## **Addendum / Addenda**

No./N°

3

Project Description / Description de projet		
M-20 Biocomposite Lab Renovation		
Solicitation No./ No de sollicitation	Project No./N° de projet	W.O. No./N° d'ordre de travail
13-22073	3714	
Departmental Representative / représentant ministériel		Date
Denis Labelle		Oct. 21, 2013
<b>Notice:</b> This addendum shall form part of the tender documents and all conditions shall apply and be read in conjunction with the original plans and specifications.		<b>Nota:</b> Cet addenda fait partie intégrale des dossiers d'appel d'offres; toutes les conditions énoncées doivent être lues et appliquées en conjonction avec les plans et les devis originaux.

dwg.no.  
**3714-G01**  
dessin no.

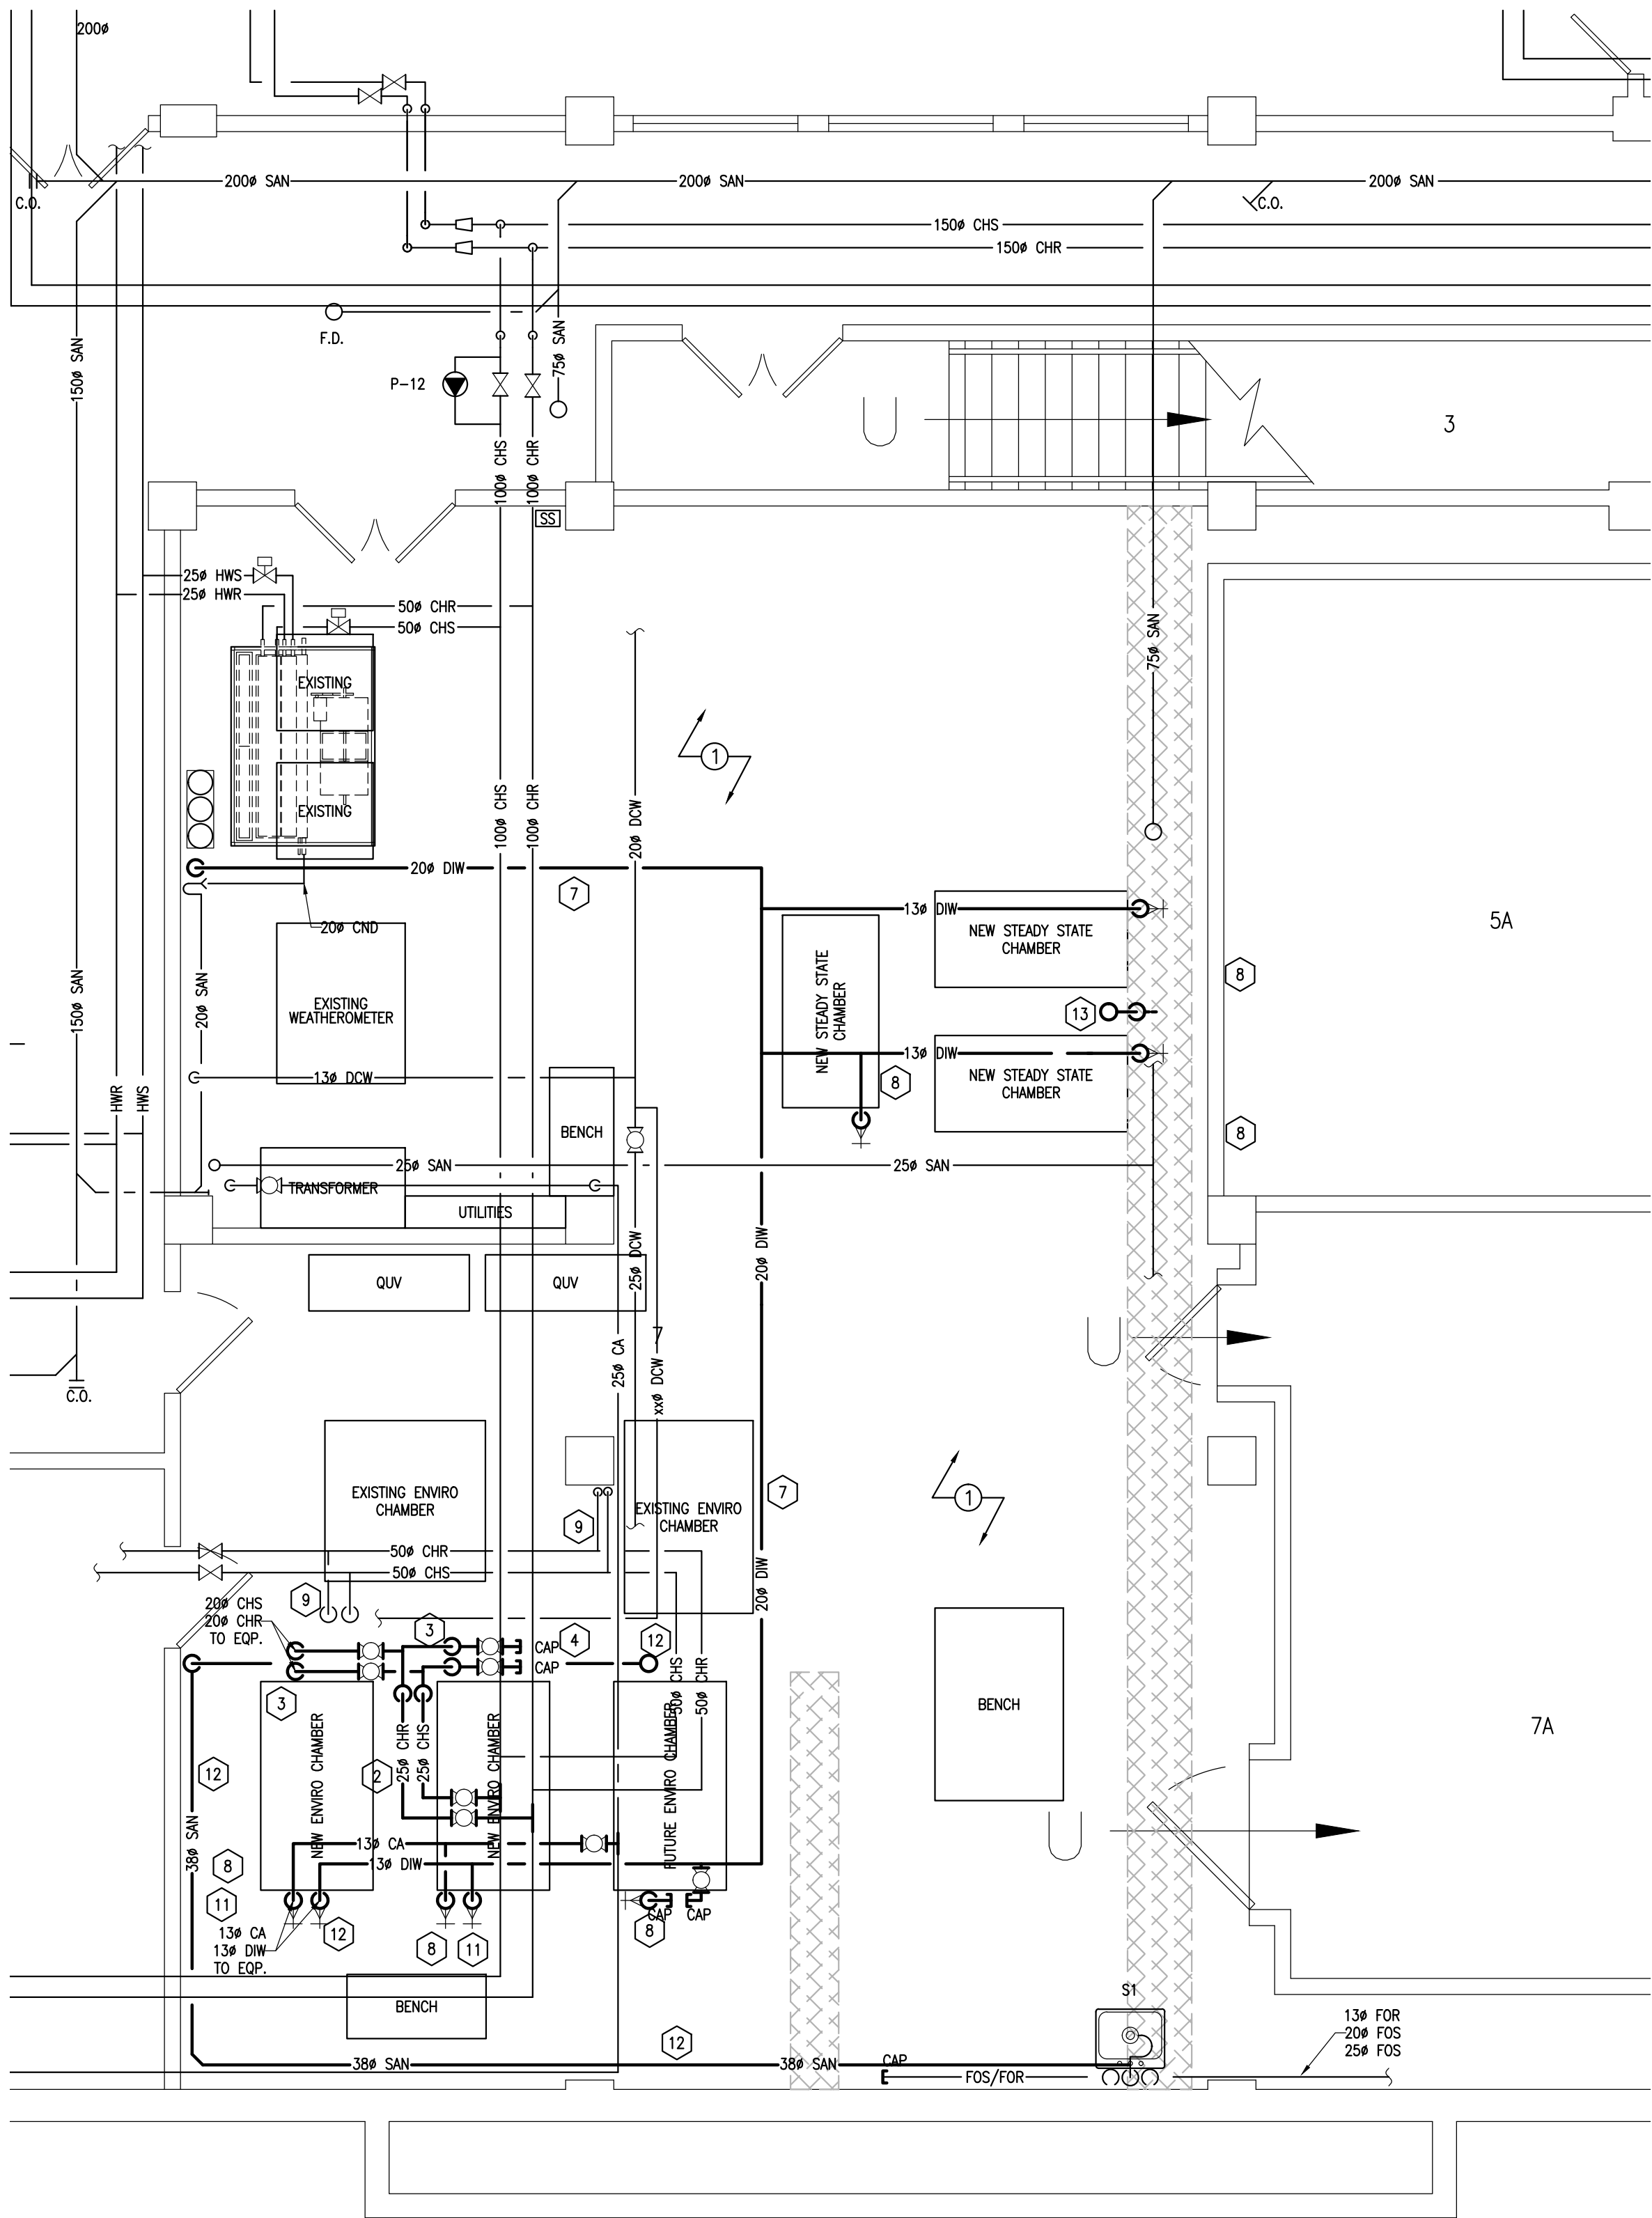
1. Replace existing drawing G01 with G01 (addendum 3). Modified drawing shows correct canopy size.

1. PROVIDE NEW CANOPY (3048MM X 3353MM-- (10FT X 11FT)), ALL REQUIRED HANGERS AND SUPPORTS, EXHAUST DUCTWORK, BALANCING DAMPERS AND REQUIRED ACCESSORIES AS INDICATED. MOUNTING HEIGHT OF CANOPY TO BE A MINIMUM OF 2440MM (8FT) TO A MAXIMUM OF 2700MM (9FT) ABOVE FLOOR LEVEL. CANOPY IS TO BE SUPPORTED FROM WALL AND FROM HANGERS FROM CEILING. PROVIDE NEW REQUIRED EXHAUST DUCT, SIZED AND LOCATED AS INDICATED FROM EXISTING TO NEW CANOPY OUTLETS (SIZED AND LOCATED AS INDICATED) C/W BALANCING DAMPERS.
